Groundwater Application Review Summary Form

Application # G- 19204

PUBLIC INTEREST REVIEW FOR GROUNDWATER APPLICATIONS

TO: Water Rights Section Date 3/14/2023
 FROM: Groundwater Section Stacey Garrison/Travis Brown
 Reviewer's Name
 SUBJECT: Application G- 19204 Supersedes review of _____
 Date of Review(s) _____

Water-Level Measurements in Nearby Wells Upper

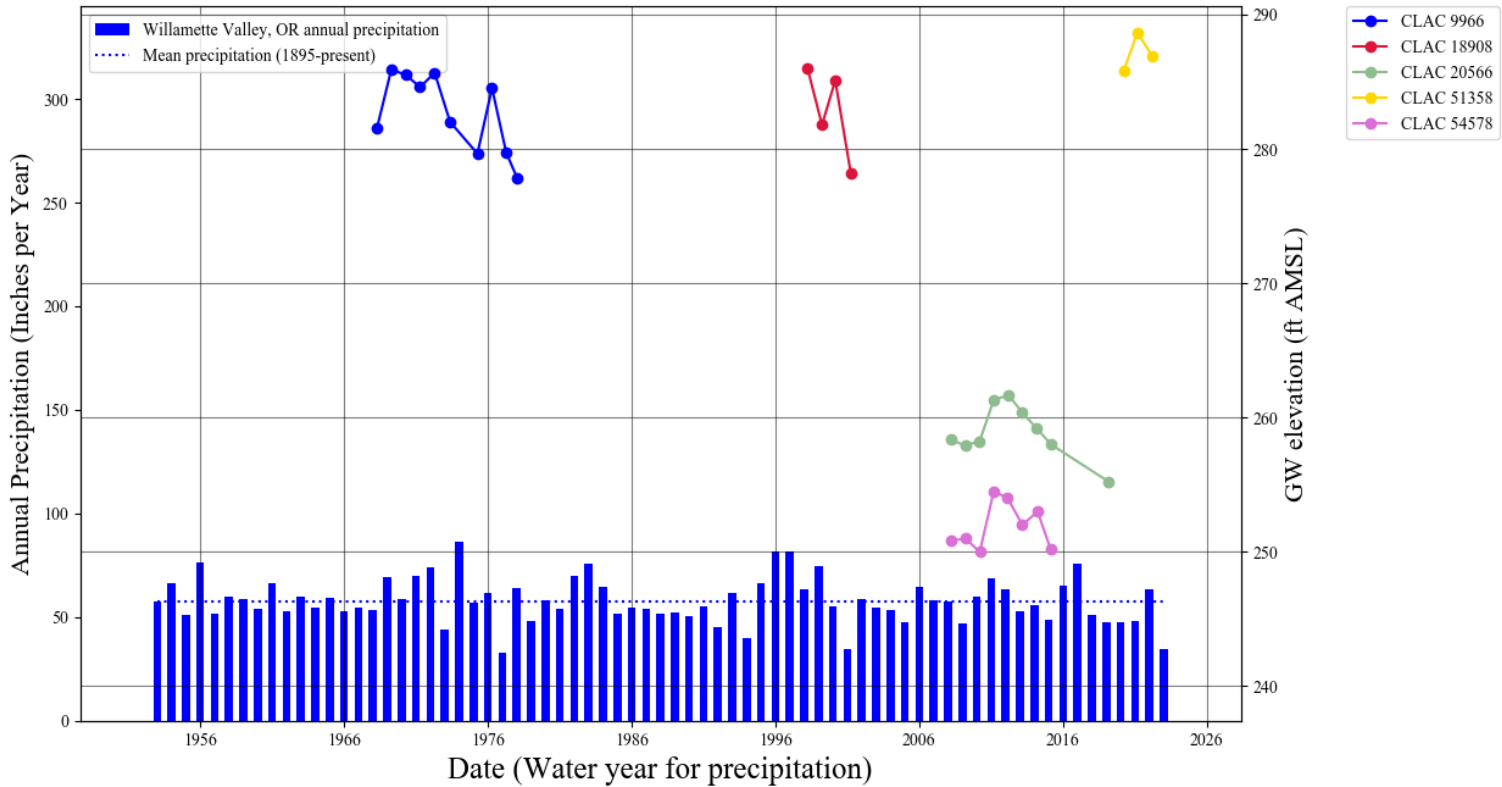
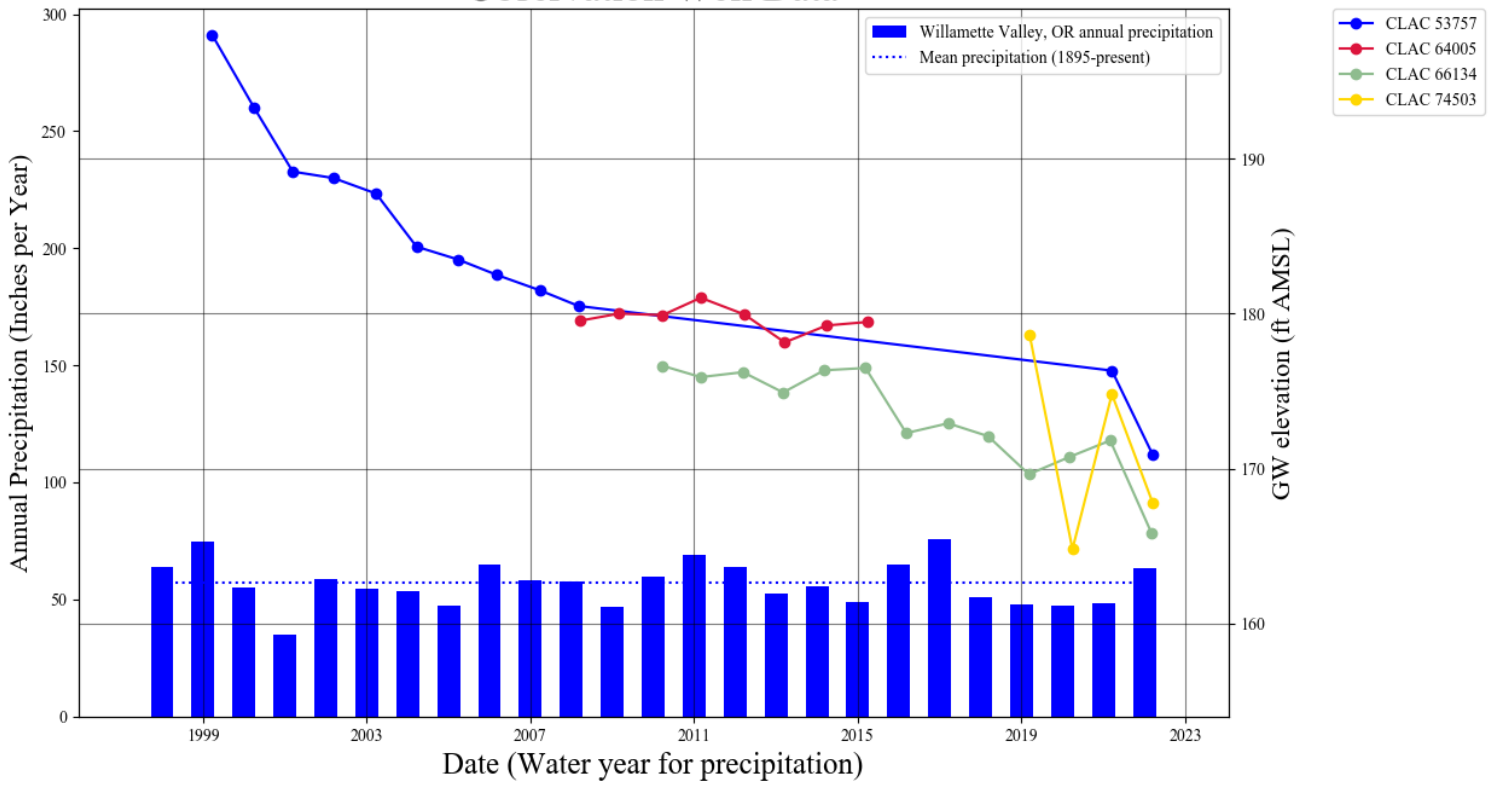
For nearby (0.2-3 miles from POAs) wells that utilize the portion of the alluvial aquifer anticipated to be targeted by the POAs, water level trends are overall steady (see Water Level Measurements in Nearby Wells-Upper, Middle). In the lower portion of the alluvial aquifer (WBZs at or less than sea level), there are three declines that exceed 10 ft: CLAC 53757 has declined approximately 27 ft over 22 years; CLAC 66134 has declined nearly 11 ft over 11 years; CLAC 74503 has declined nearly 11 ft over 3 years (see Water Level Measurements in Nearby Wells-Lower). The lower portion is less likely to receive regular annual recharge, but is not anticipated to be representative of water supply conditions in the portion of the aquifer targeted by the POAs. There is not a preponderance of evidence to support that the water levels in the groundwater reservoir are declined excessively or excessively declining; therefore, the groundwater reservoir is not over-appropriated.

Well Statistics 5S/2E-17 and surrounding sections, completed depth of 150 to 350 ft bls

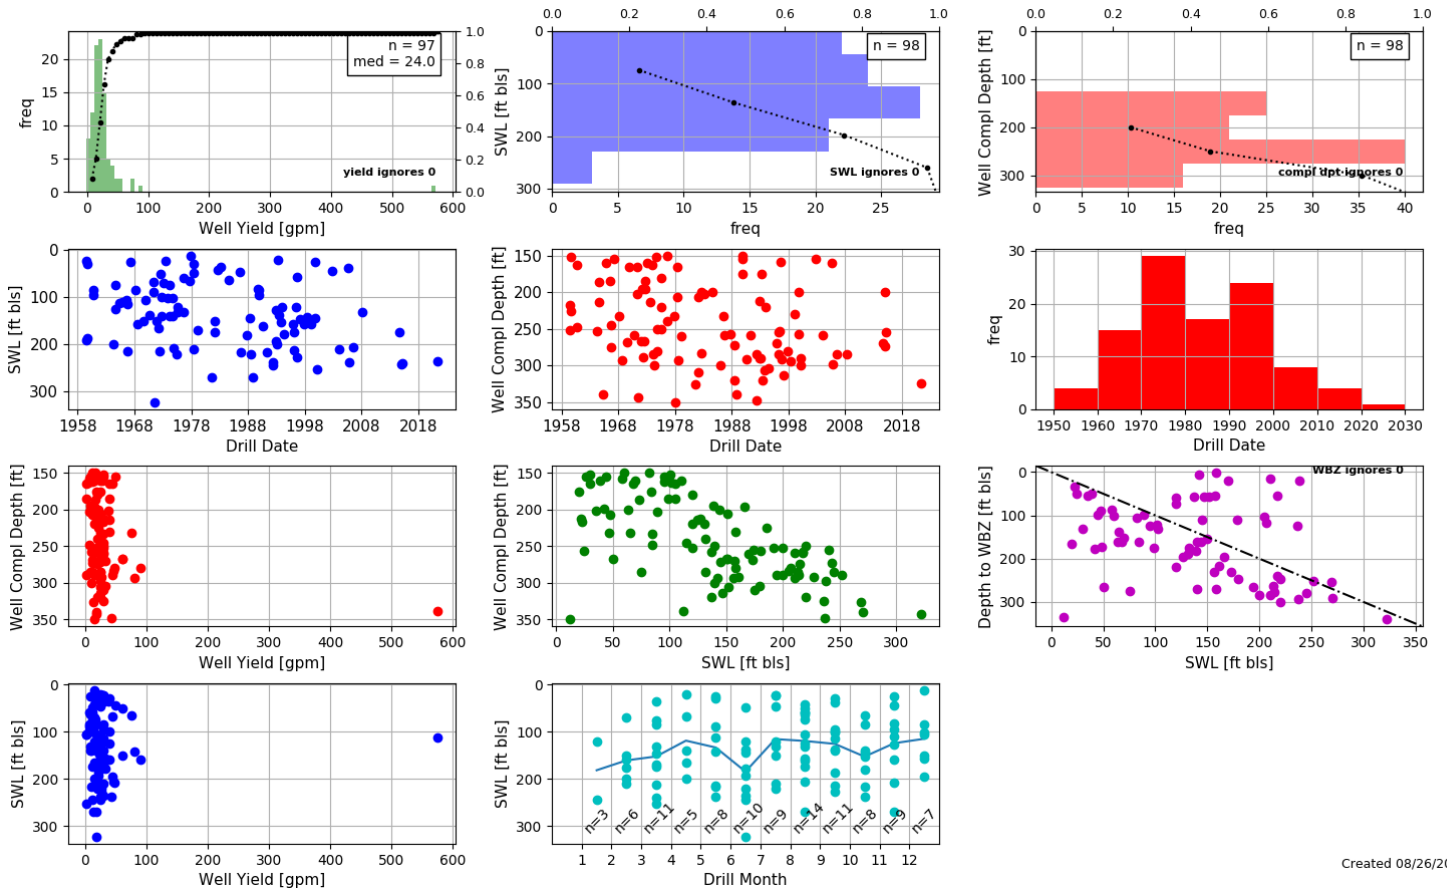
- B3. **Groundwater availability remarks:** The proposed POAs/POUs are on the Troutdale Formation, a late-tertiary deposit of fluvial and lacustrine origin, composed primarily of conglomerate and tuffaceous sandstone (Trimble 1963, Hampton 1972). Where hardened, the cement of Troutdale Formation layers is composed of somewhat permeable clay minerals (Trimble 1963). Hampton (1972) estimated the Troutdale Formation is likely to be up to 300 ft thick in this area. Department-located wells within 1 mile of the POAs (CLAC 10370, CLAC 10371, CLAC 10071, CLAC 10257, CLAC 10256, CLAC 20145, CLAC 10280, CLAC 10404) do not exceed 150 ft in depth below land surface, bls. The water-bearing zones, WBZs, are between 50 and 150 ft bls, range in thickness from 1 to 11 ft, and are described in well logs as mixtures of sand, conglomerate, gravel, and clay. Based on the depth and pumping rate of the proposed wells, it is anticipated that the POAs will utilize deeper WBZs with higher yields. There are 102 wells in the surrounding sections of 5S/2E that range in depths from 150 to 350 ft; most of these wells report yields less than 50 gpm. Of the 102, there are 6 wells that report yields above 50 gpm, however, the tests are either air tests (CLAC 58330, CLAC 53324, CLAC 52373, CLAC 10299) or do not report the type of test used (CLAC 10027, CLAC 10900). Location of the three wells with air tests is known to the taxlot scale (CLAC 58330, CLAC 53324, CLAC 52373); these wells are considered in this review as proxies for the anticipated lithology and likely construction of the proposed POAs. These wells utilize WBZs in sand, gravel, and cobble layers that range in thickness from 3 to 21 ft, with WBZ elevations ranging from as 40 to 176 ft msl. The SWLs range from 196 to 268 ft msl, and all three wells tap confined aquifers with confining beds of brown, gray and blue clays, indicating that the wells are likely accessing the Willamette aquifer (Gannett & Caldwell 1998, Conlon et al 2005, Swanson et al 1993). There is a wide variability in hydraulic characteristics of the Willamette aquifer, owing to the variety of compositions and degree of consolidation (O'Connor et al 2001). Based on the relative thinness of the WBZs and intervening layers of clay, silt, and similar lithologies, the WBZs are likely to be formations from discontinuous braided stream deposits (Gannett & Caldwell 1998). A review of statistics for nearby well records was completed and compared with the proposed rate of 0.22 cfs (98.7 gpm) for this application (see Well Statistics). The proposed rate of use of 0.22 cfs (98.7 gpm) is likely within the capacity of the

groundwater resource; median reported well yield is 24 gpm, and the maximum reported yield is 575 gpm. The proposed rate for this application is 411% of the median and 17% of the maximum reported yield. Previous studies have reported yields for wells using the Willamette aquifer ranging from 64 to 980 gpm, however the higher reported yields are likely utilizing unconsolidated and/or gravel water-bearing zones (Woodward et al 1998).

Well 1

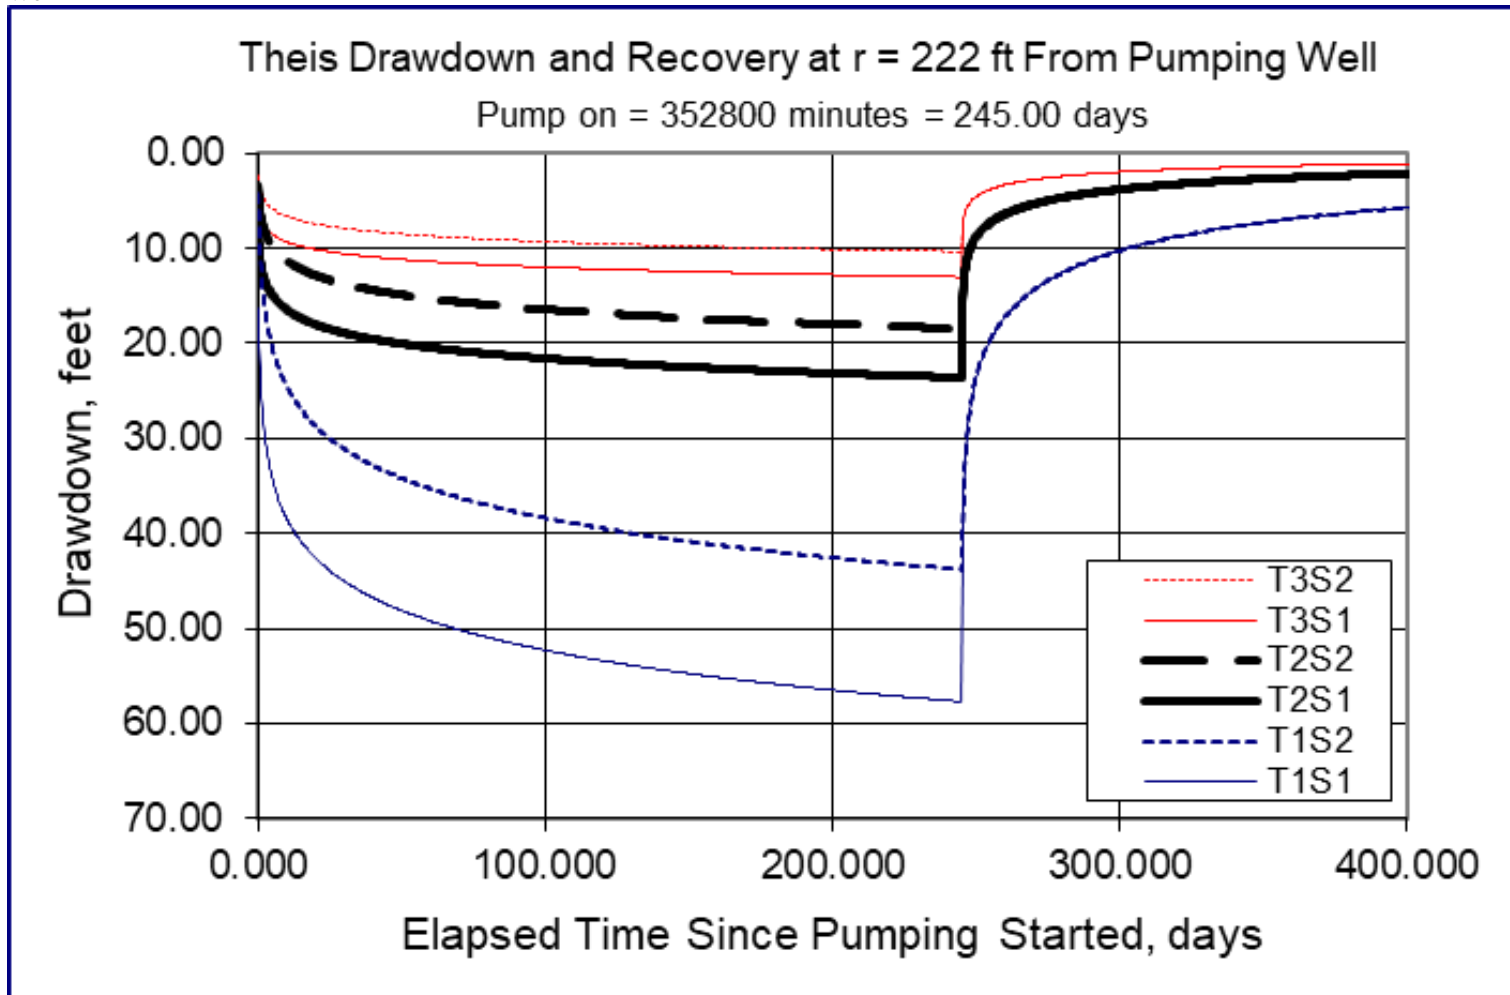
The nearest groundwater user to Well 1 is CLAC 57932 (an exempt domestic well), 222 ft northwest of the POA at an elevation of ~446 ft msl. It is likely the proposed use would cause some degree of well-to-well interference with CLAC 57932. To assess the degree of drawdown, a Theis drawdown analysis was conducted for the proposed use (see attached **Theis Drawdown Analysis-Well 1**). Results indicate that the proposed use is not likely to cause well-to-well interference with CLAC 57932 that exceeds the threshold under the standard condition for alluvial aquifers in the Willamette Basin.

Based on this analysis of the available data and under the assumptions previously identified, groundwater for the proposed use is likely available within capacity of the resource; if a permit is issued for this application, the conditions in B1(d)(i) and B2(c) are recommended to protect senior users and the groundwater resource.

Well 2

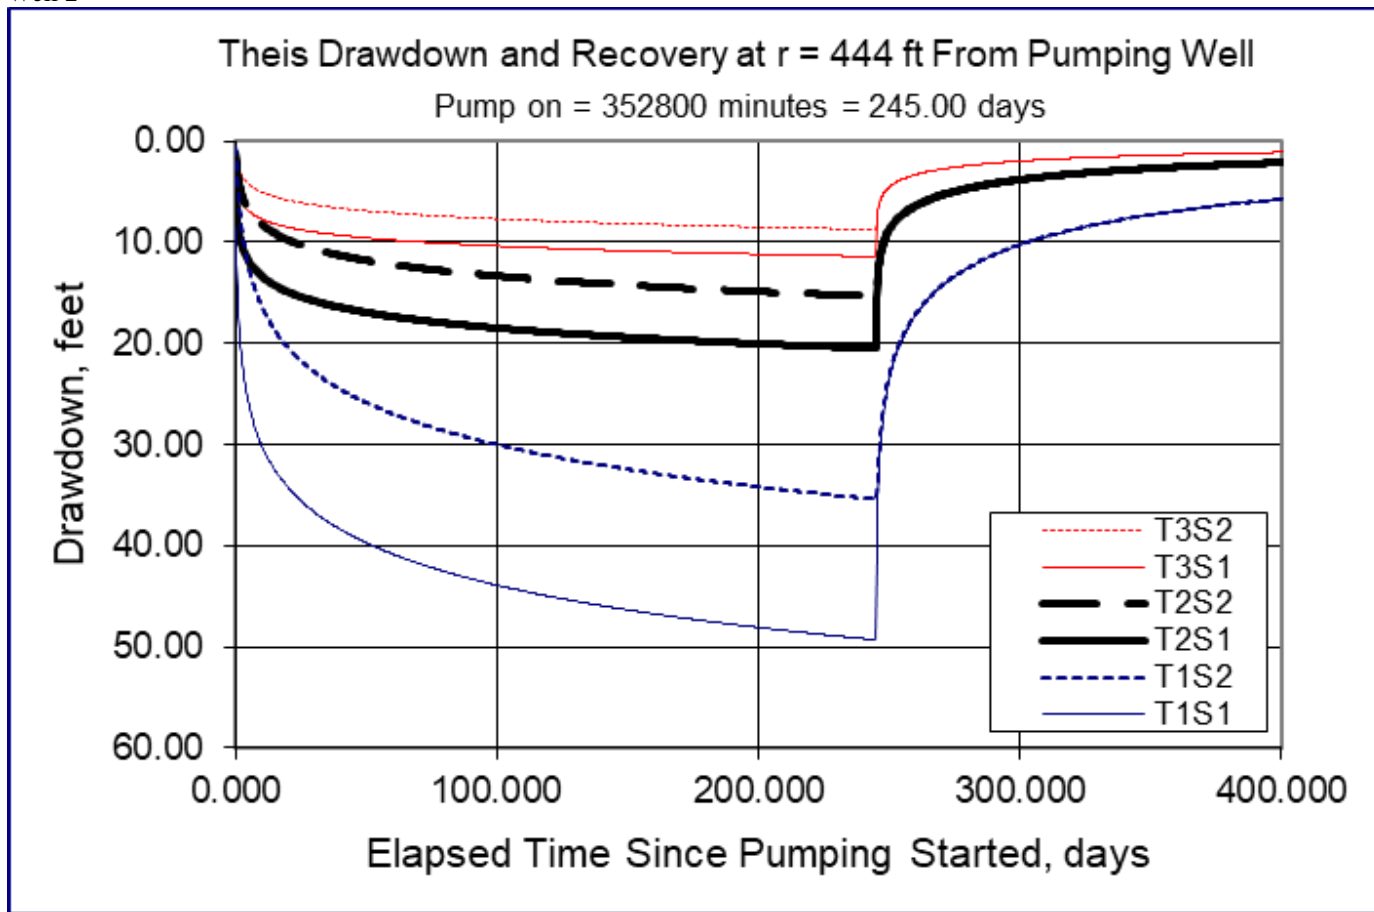
The nearest groundwater user to Well 2 is at taxlot 1705, 32817 S Wilhoit Rd Molalla OR (an exempt domestic well) is 444 ft northeast of the POA at an elevation of ~443 ft msl. With the same drill year as the house construction and in the same township/range/section, CLAC 10257 is a potential match for this taxlot. The well's location is assumed to be the center of the developed portion of the taxlot. CLAC 10257 is drilled to 67 ft bls [376 ft msl] with a WBZ from 62 to 63 ft bls [380 to 381 ft msl], and a seal depth of 22 ft bls [421 ft msl]. It is likely the proposed use would cause some degree of well-to-well interference with CLAC 10257. To assess the degree of drawdown, a Theis drawdown analysis was conducted for the proposed use (see attached **Theis Drawdown Analysis-Well 2**). Results indicate that the proposed use is not likely to cause well-to-well interference with CLAC 10257 that exceeds the threshold under the standard condition for alluvial aquifers in the Willamette Basin.

Well 3

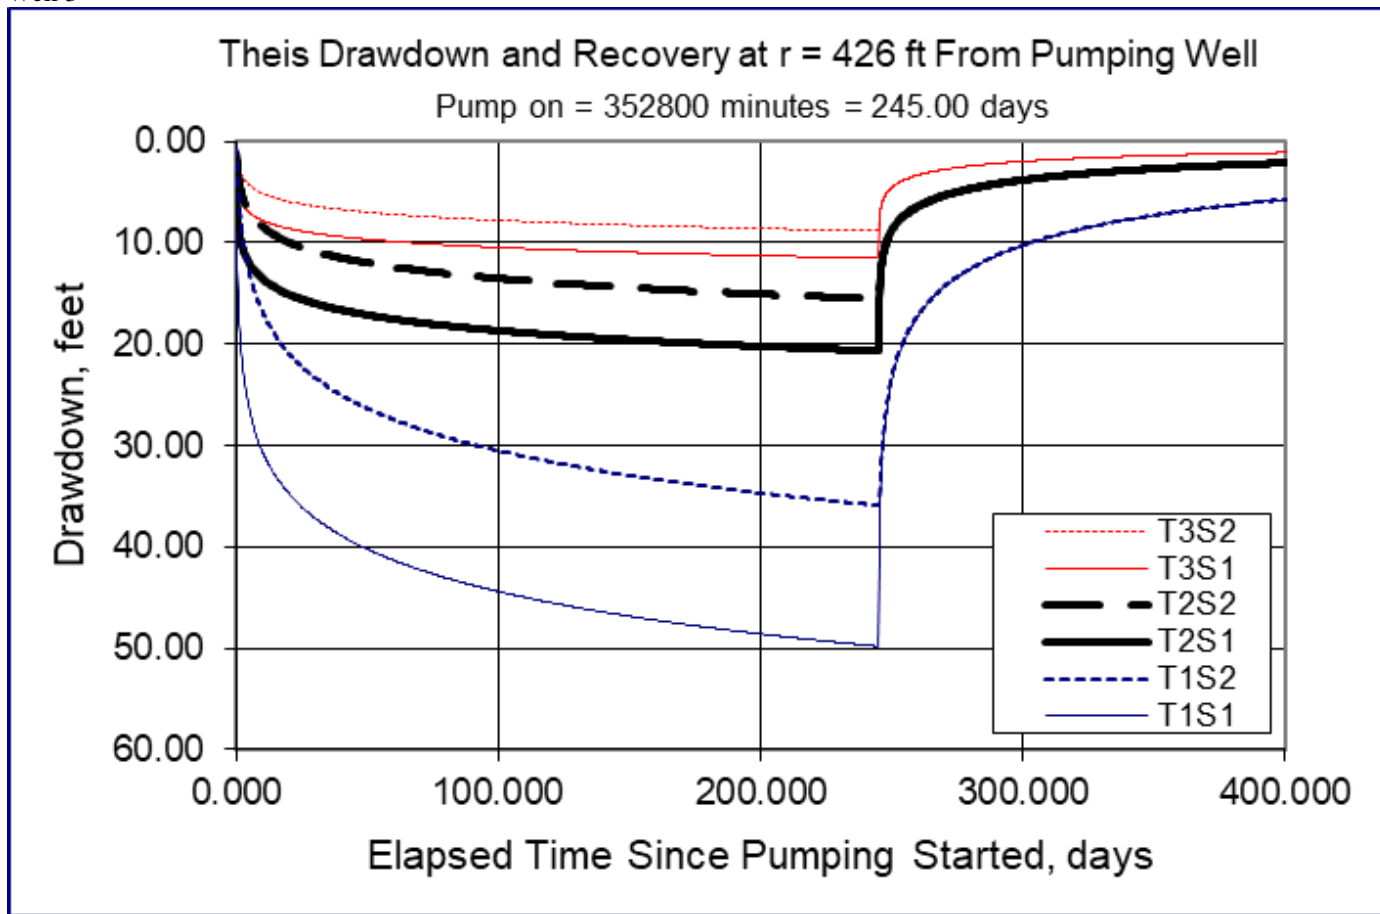
The nearest groundwater user to Well 3 is CLAC 20145 (an exempt domestic well), 426 ft northeast of the POA at an elevation of ~480 ft msl. CLAC 20145 is drilled to 86 ft bls [394 ft msl] with a WBZ from 73 to 77 ft bls [403 to 407 ft msl], and a seal depth of 35 ft bls [445 ft msl]. It is likely the proposed use would cause some degree of well-to-well interference with CLAC 20145. To assess the degree of drawdown, a Theis drawdown analysis was conducted for the proposed use (see attached **Theis Drawdown Analysis-Well 3**). Results indicate that the proposed use is not likely to cause well-to-well interference with CLAC 20145 that exceeds the threshold under the standard condition for alluvial aquifers in the Willamette Basin.

Well 4

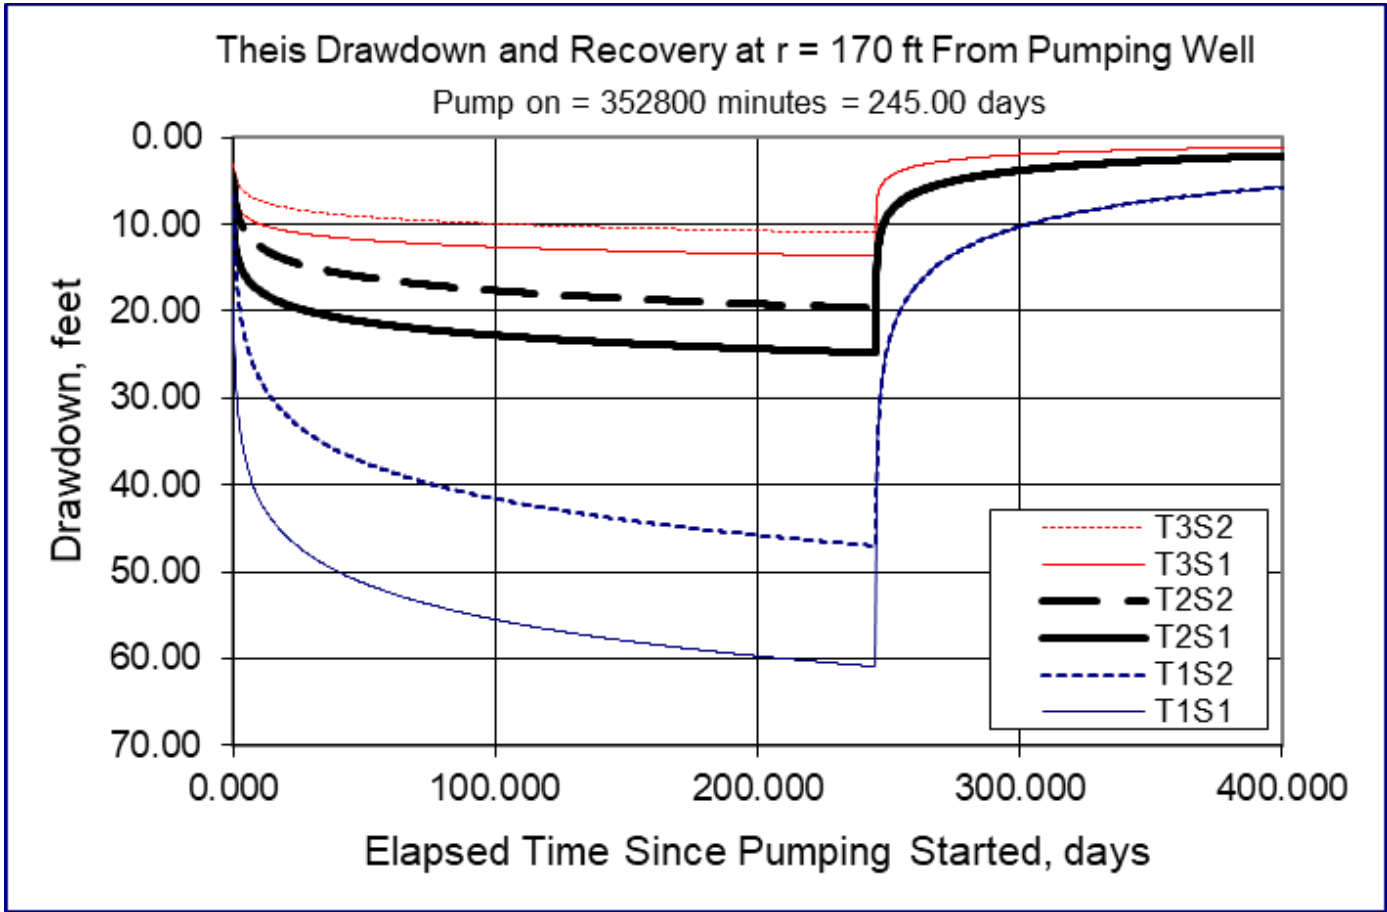
The nearest groundwater user to Well 4 is at taxlot 101, 32891 S Sawtell Rd Molalla OR (an exempt domestic well), 170 ft northwest of the POA at an elevation of ~465 ft msl. CLAC 10280 is a likely match for this location, with matching owner name and township/range; the well's location is assumed to be the center of the developed portion of the taxlot. CLAC 10280 is drilled to 135 ft bls [330 ft msl] with a WBZ from 88 to 95 ft bls [370 to 377 ft msl], and a seal depth of 23 ft bls [442 ft msl]. It is likely the proposed use would cause some degree of well-to-well interference with CLAC 10280. To assess the degree of drawdown, a Theis drawdown analysis was conducted for the proposed use (see attached **Theis Drawdown Analysis-Well 4**). Results indicate that the proposed use is not likely to cause well-to-well interference with CLAC 20145 that exceeds the threshold under the standard condition for alluvial aquifers in the Willamette Basin.
